PD Modification Application PRS 22-1006

**Hillsborough
County Florida**

Request Minor Modification to PD 82-0275

AGENCY REVIEW COMMENT SHEET

8.2 Proposed Site Plan (Full)

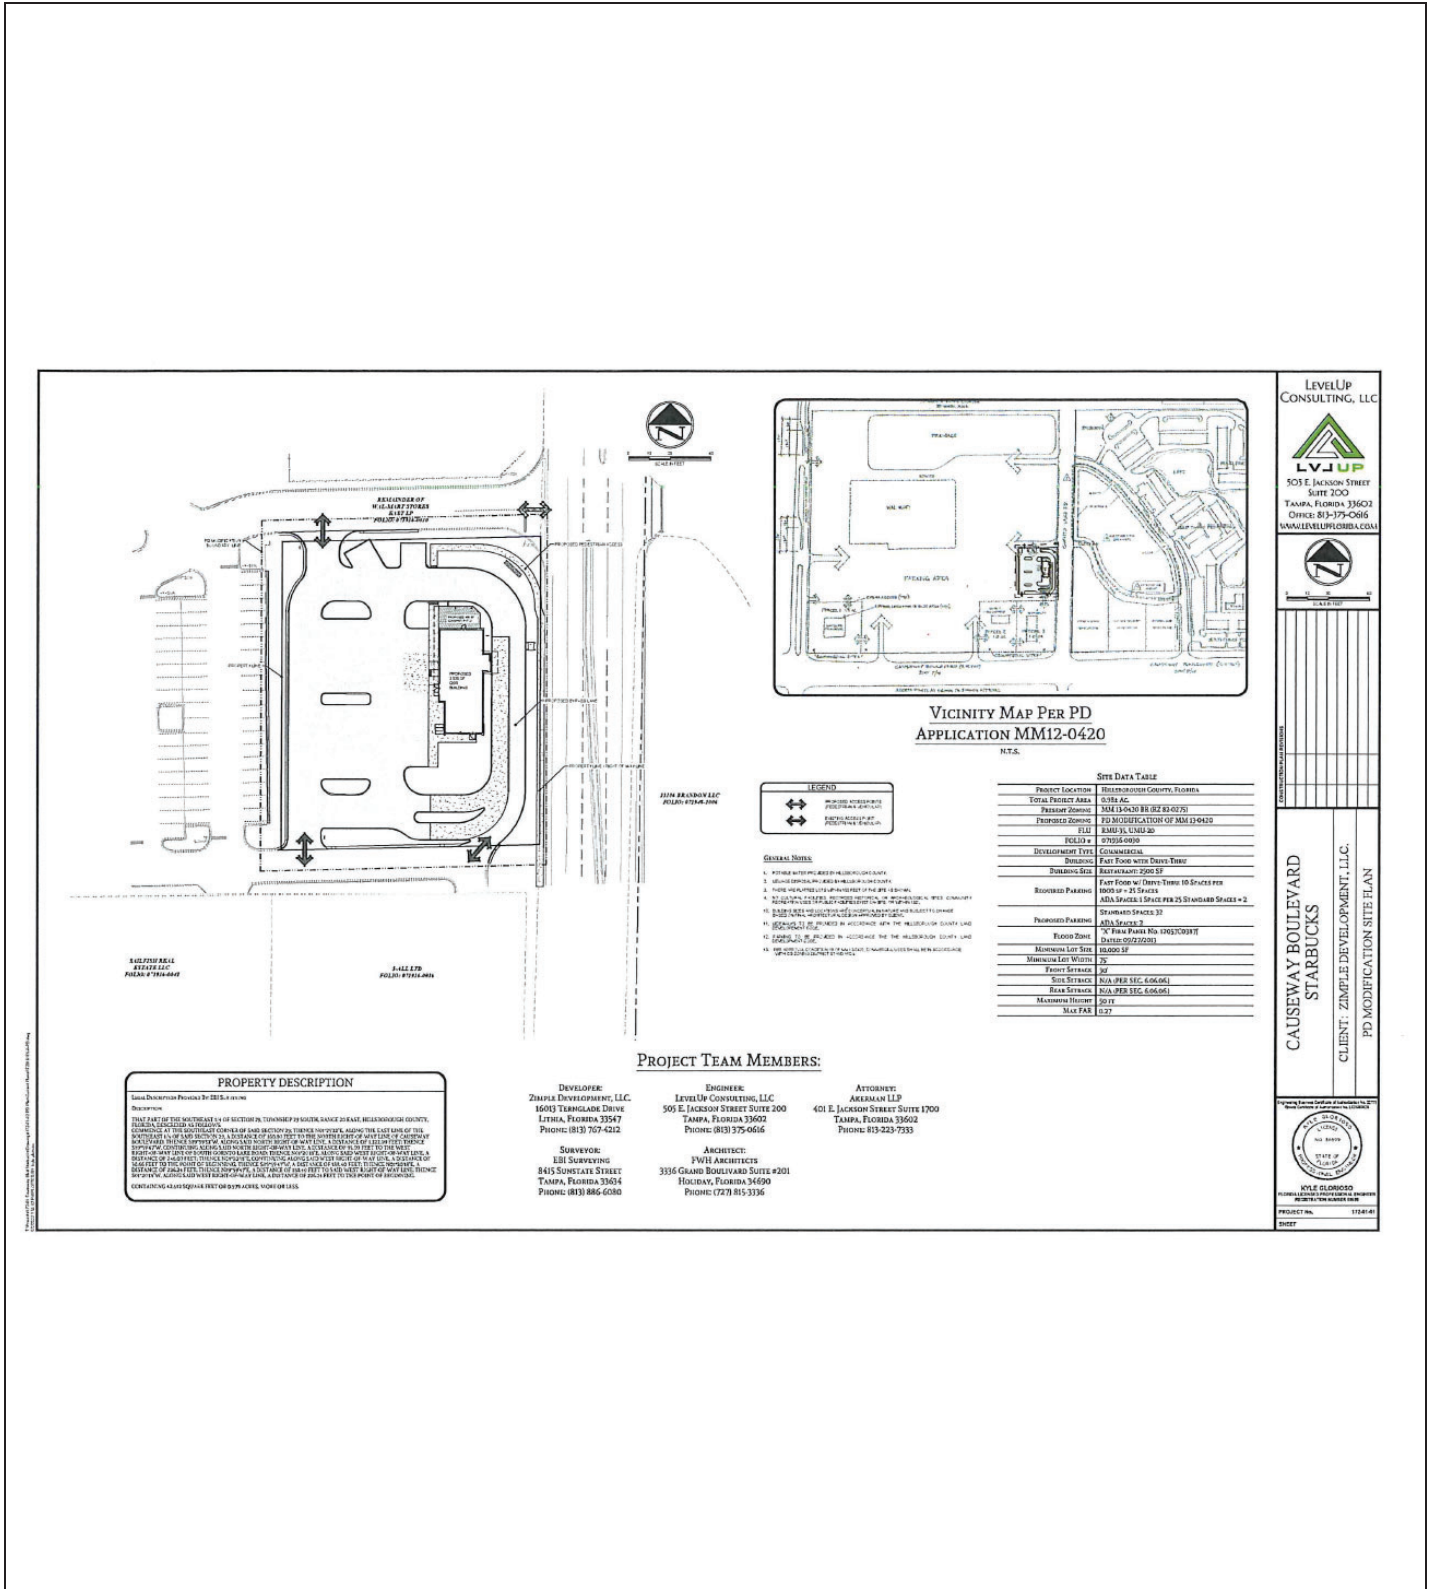
- a. The PD site plan in Optix is blurry and notes cannot be clearly read. Please ensure a legible copy is in Optix so staff can conduct a thorough review.

- g. The proposed sidewalk along Gornto Lake Rd. is not placed in a location consistent with the TTM requirements. As such, the site must be redesigned to meet standards, or a DE to the applicable TTM Typical Section is required. Also, sidewalk appears to encroach on the subject property, therefore an easement will be required pursuant to Sec. 6.03.02.D.

- h. The PD site plan does not meet DRPM minimum requirements. Please ensure all minimum requirements have been met. Staff can provide additional guidance if necessary.

- j. The applicant's proposed connection to the internal drive aisle along the northern boundary does not meet minimum throat depth standards. Pursuant to Sec. 6.04.04.A.2., the minimum throat depth must be 250 feet. Please redesign accordingly. Staff believes an Administrative Variance to permit a lower standard might be supportable given site layout and constraints; however, the applicant is requested to schedule a coordination meeting with Transportation Review Section staff to discuss before submitting a formal AV request.

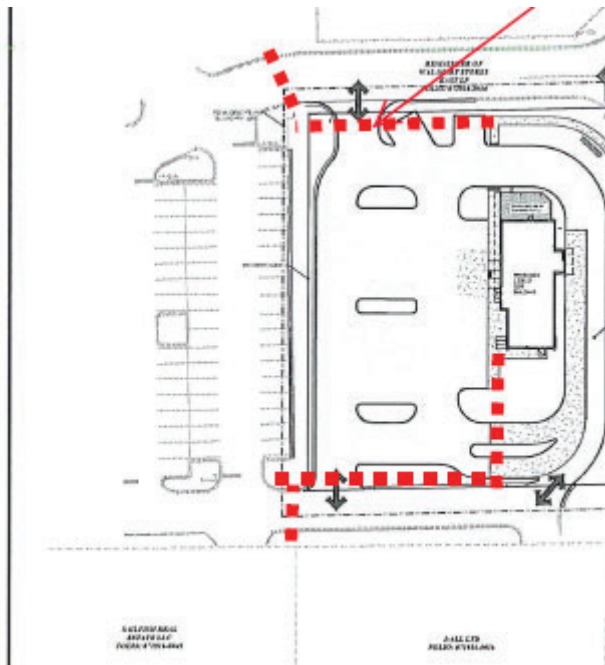
- i. Sidewalks are needed as shown by the red dashed line in the image below in order to facilitate compliance with Sec. 6.03.02.A. and 6.03.02.B.2. The goal is to provide an immediate connection to the sidewalk on Gornto Lake and a portion of the future sidewalk network needed to connect each site arrival point as well as to the other uses within the PD as required by the LDC. Please redesign accordingly.

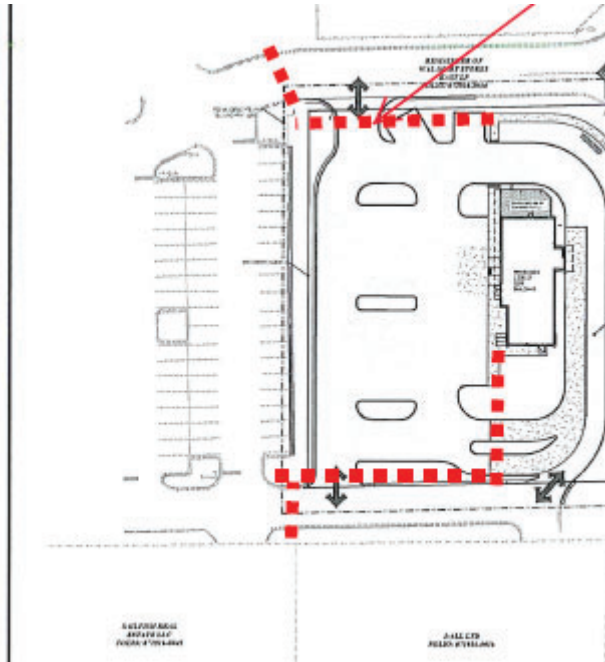
- i. Sidewalks are needed as shown by the red dashed line in the image below in order to facilitate compliance with Sec. 6.03.02.A. and 6.03.02.B.2. The goal is to provide an immediate connection to the sidewalk on Gornto Lake and a portion of the future sidewalk network needed to connect each site arrival point as well as to the other uses within the PD as required by the LDC. Please redesign accordingly.
